PROPOSED TECHNICAL SPECIFICATION

ENTERGY OPERATIONS, INC.

ARKANSAS NUCLEAR ONE, UNIT ONE

Subject: Arkansas Nuclear One - Unit 1
Docket No. 50-313
License No. DPR-51
Proposed Technical Specification Change Revising The Pressurizer Code Safety
As-Found Setpoint Tolerance

FIG. NO.
14-1

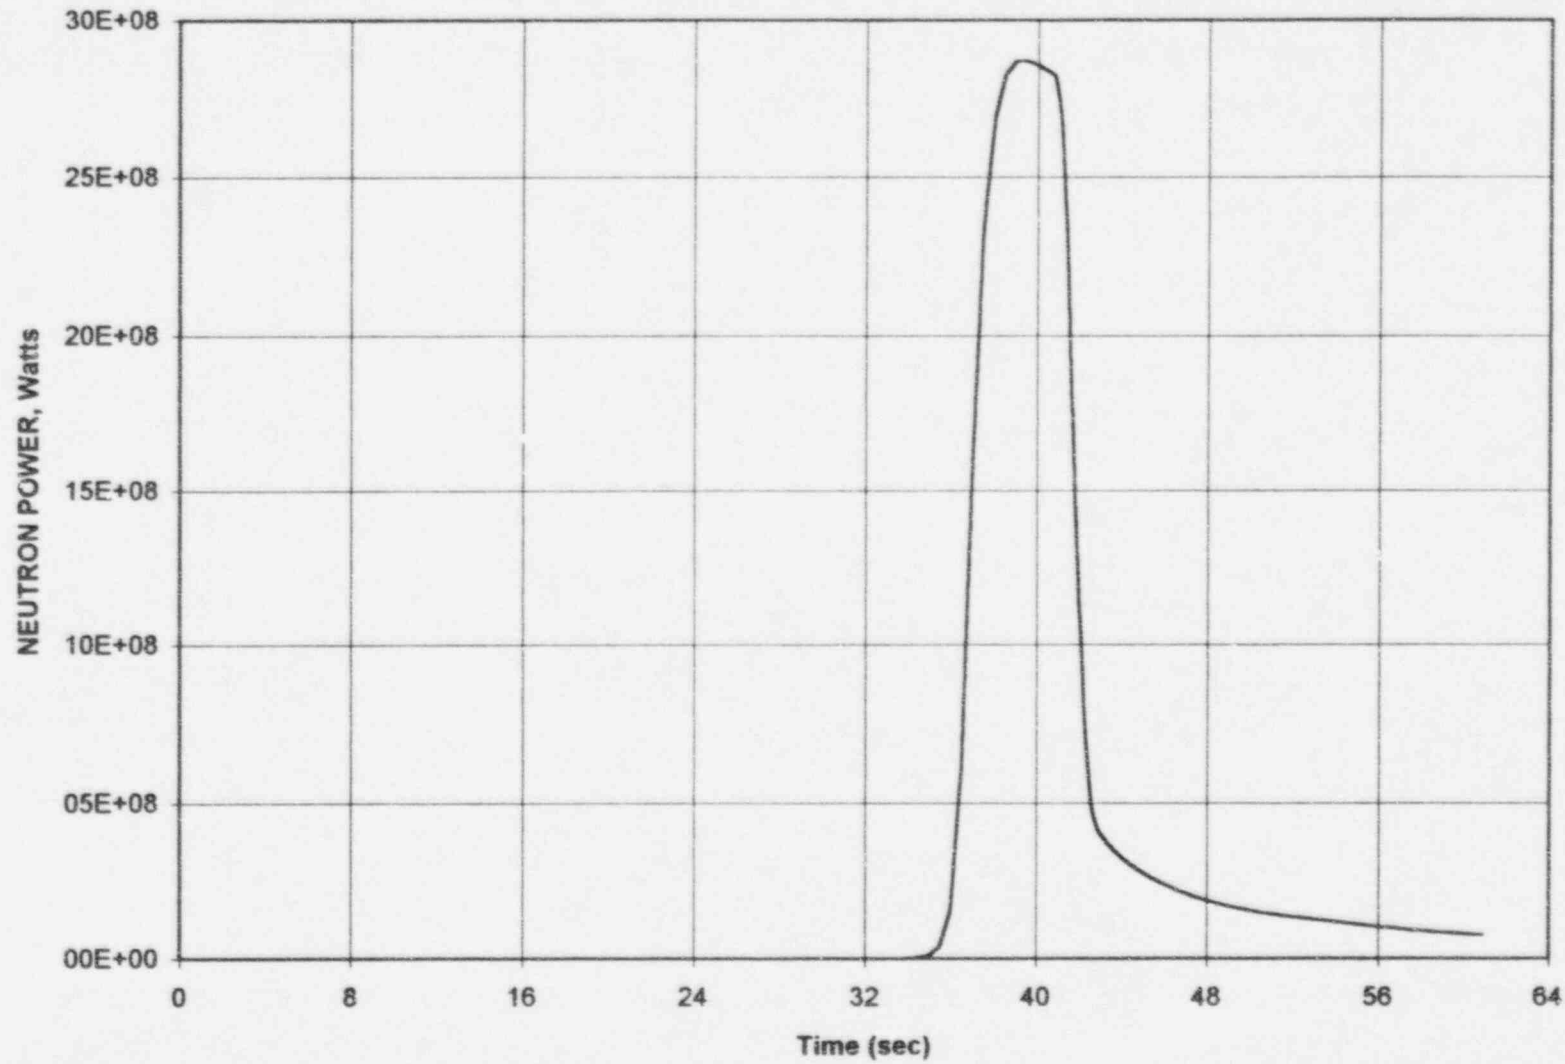
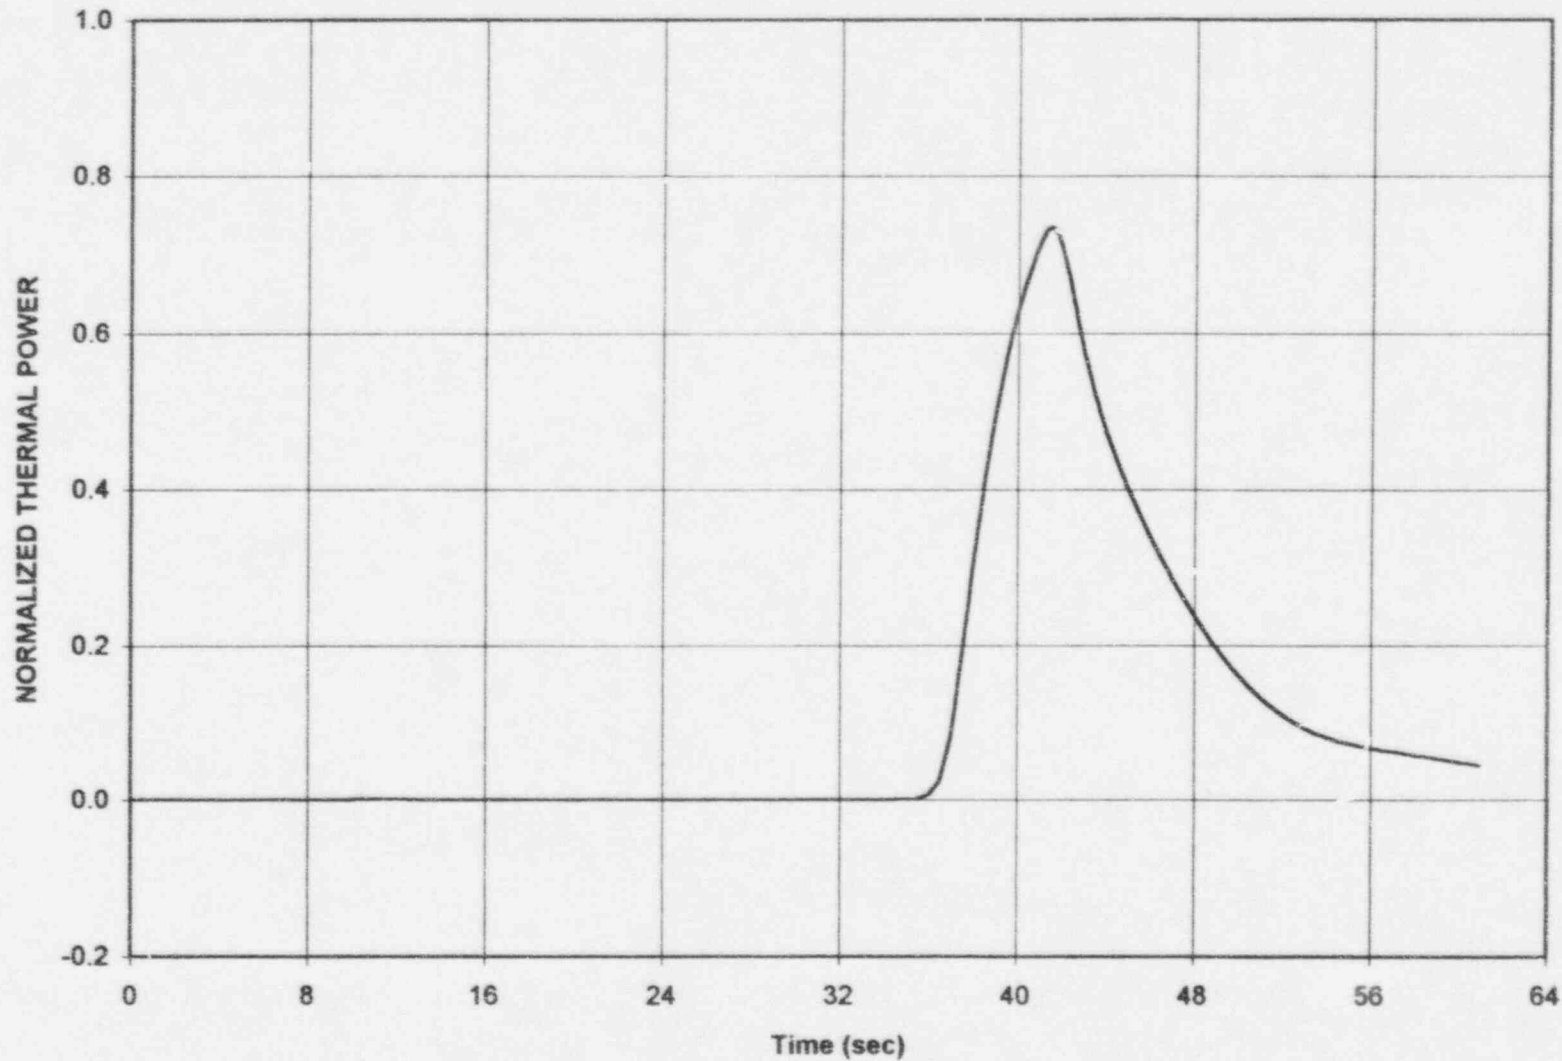
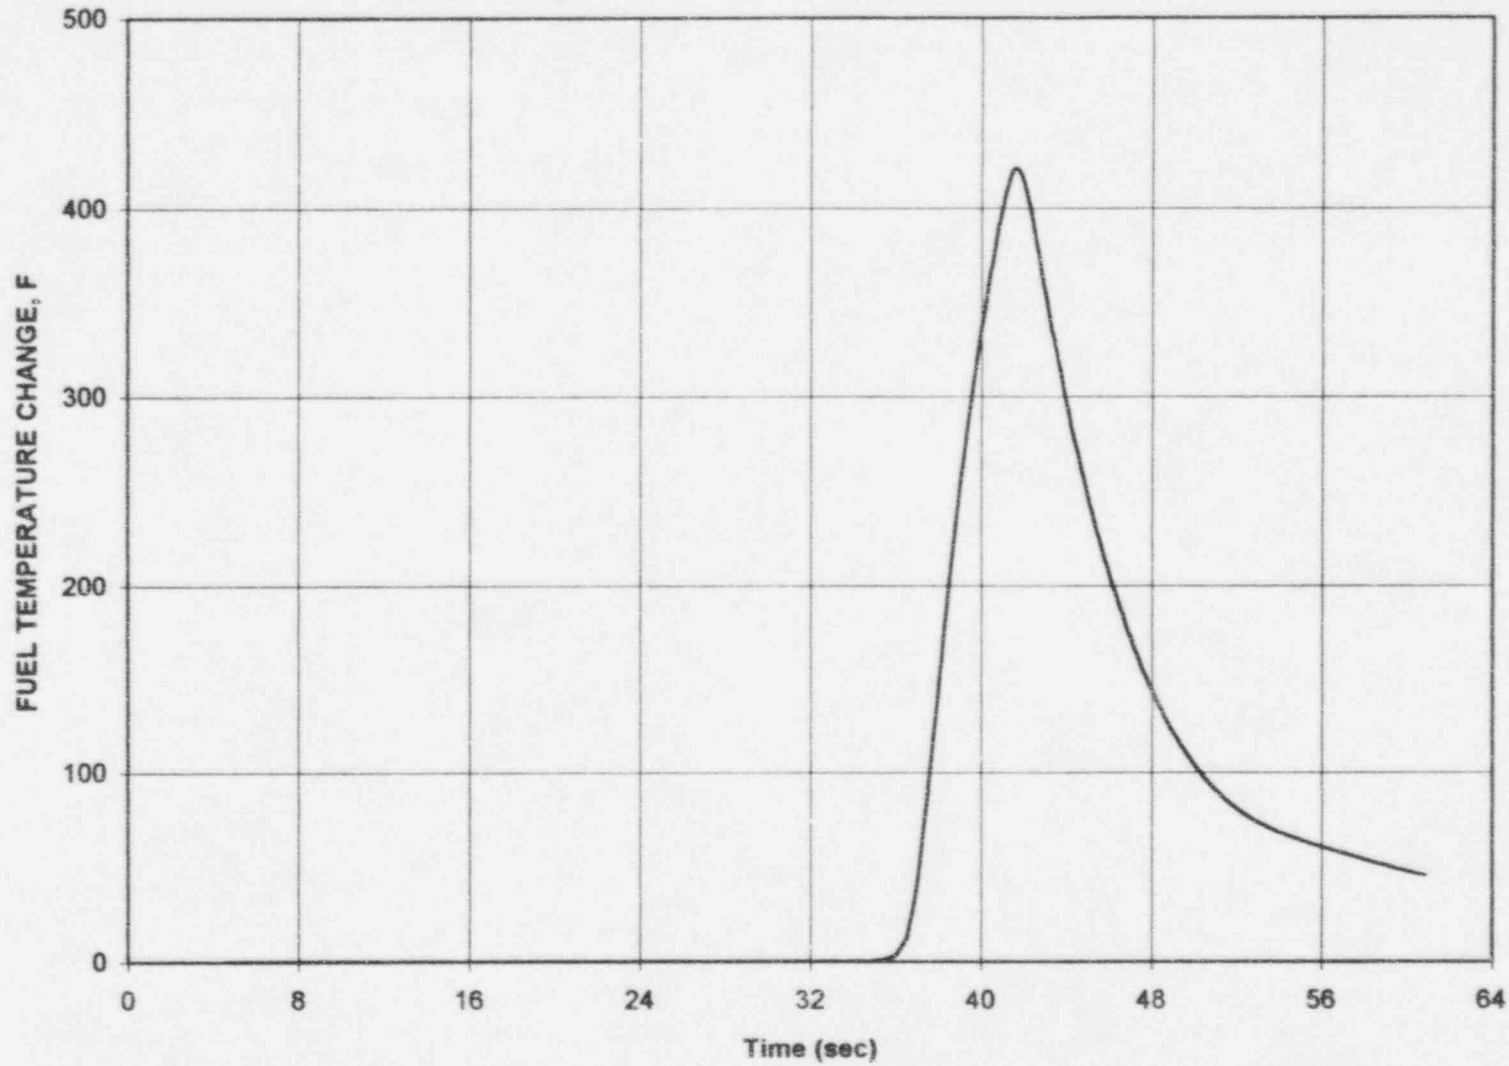
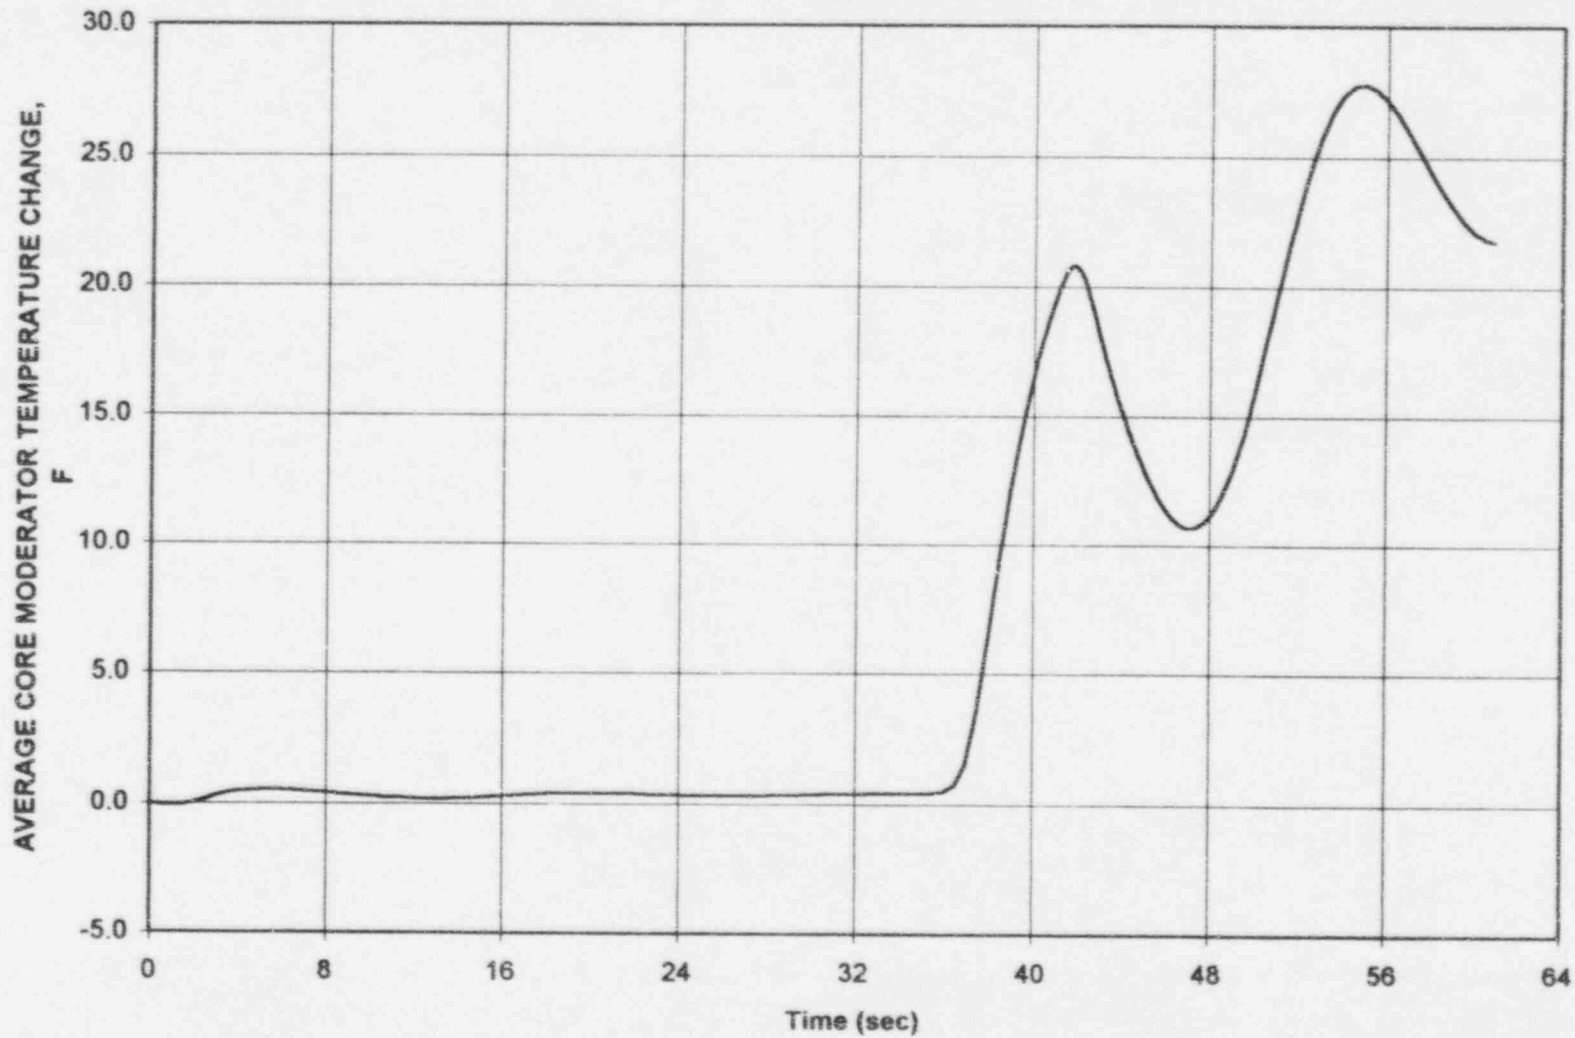
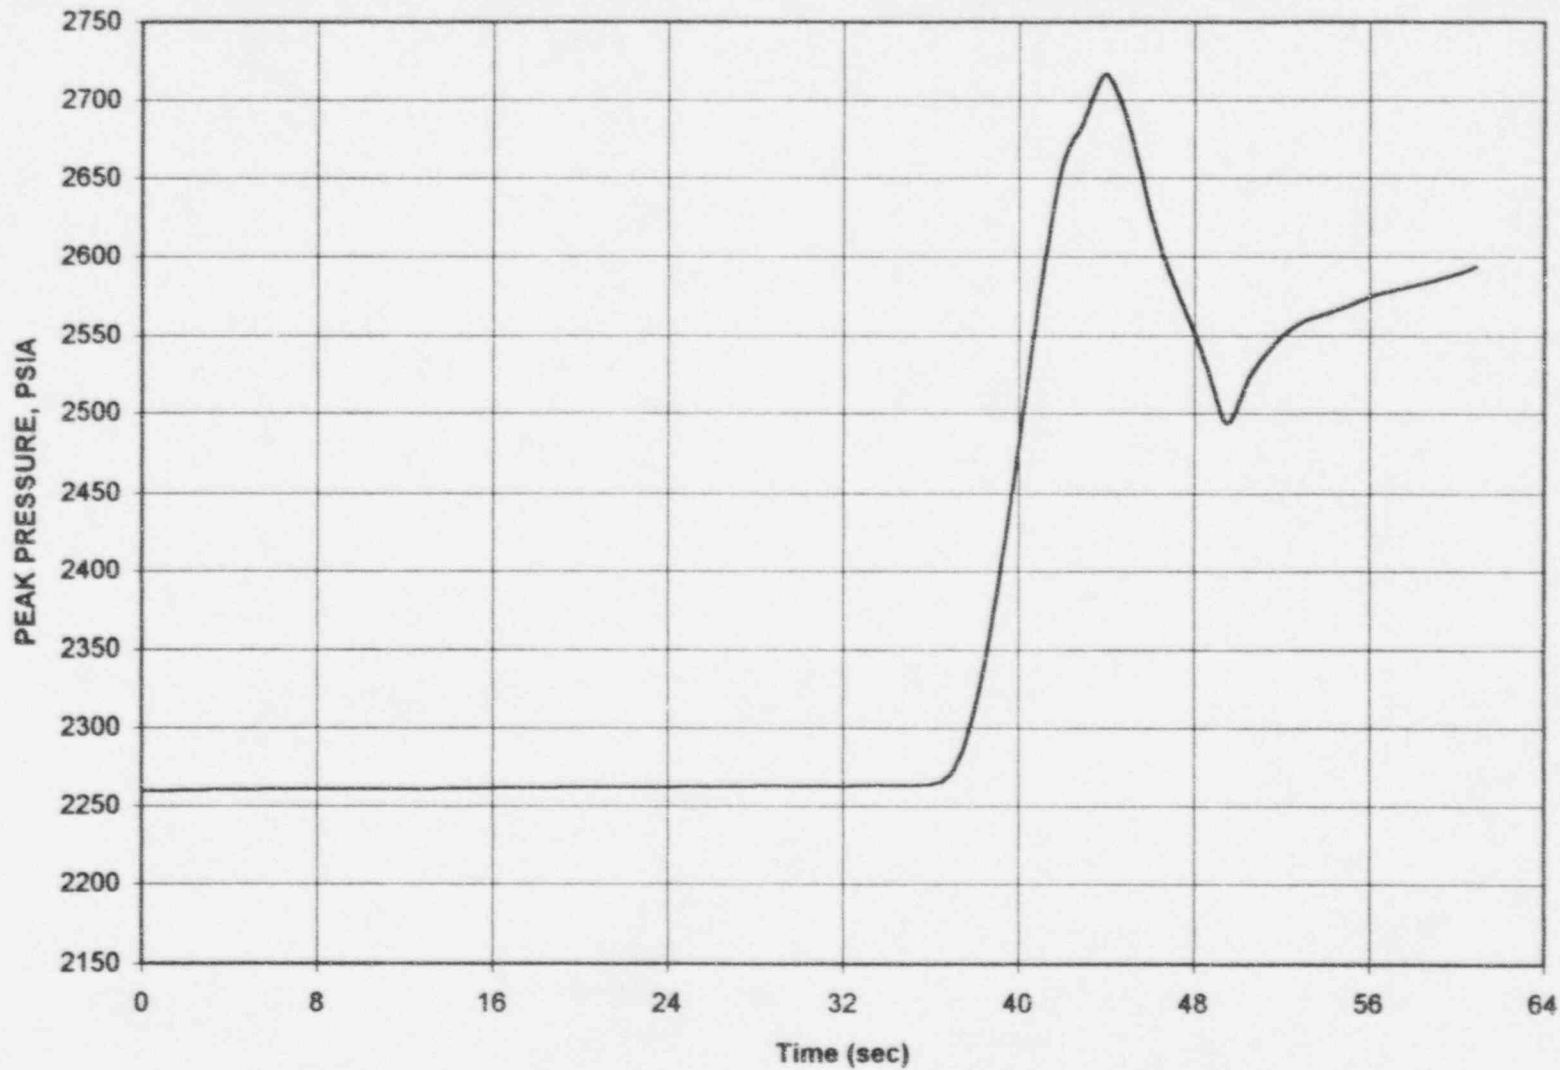
Figure 14-1 shows the results of ^{the reactivity addition rate that results in the peak pressure and thermal power.} withdrawing the maximum worth/control rod group at the maximum rod speed from 0.5% $\Delta k/k$ subcritical. This rod velocity and worth result in the maximum reactivity addition rate. The Doppler effect terminates the neutron power (neutron power is defined as the total energy release from fission) rise, but the heat input to the reactor coolant increases the pressure past the trip point and the transient is terminated by the high pressure trip.

FIG. NO.
14-4

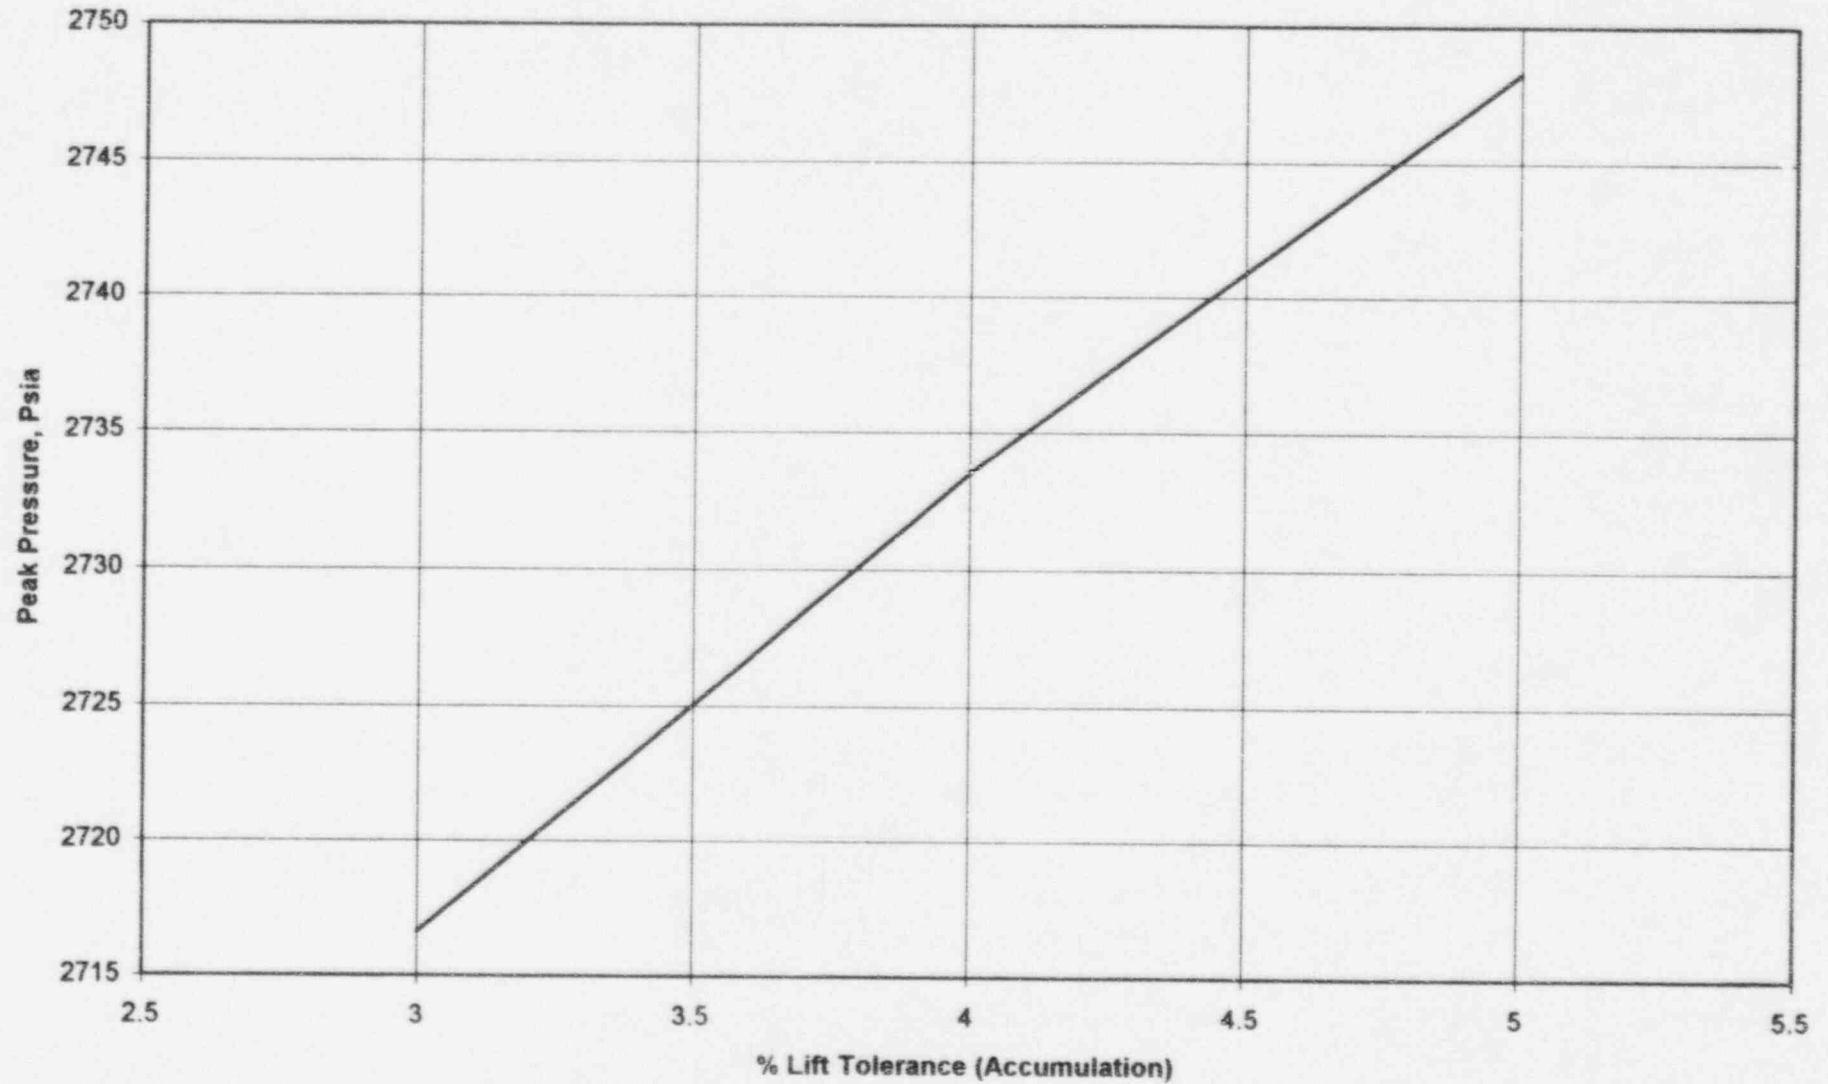
Figure 14-4 shows the effect of varying the pressurizer safety valve (PSV) lift setpoint tolerance (accumulation) from 3% to 5% (assuming all other inputs remain constant).
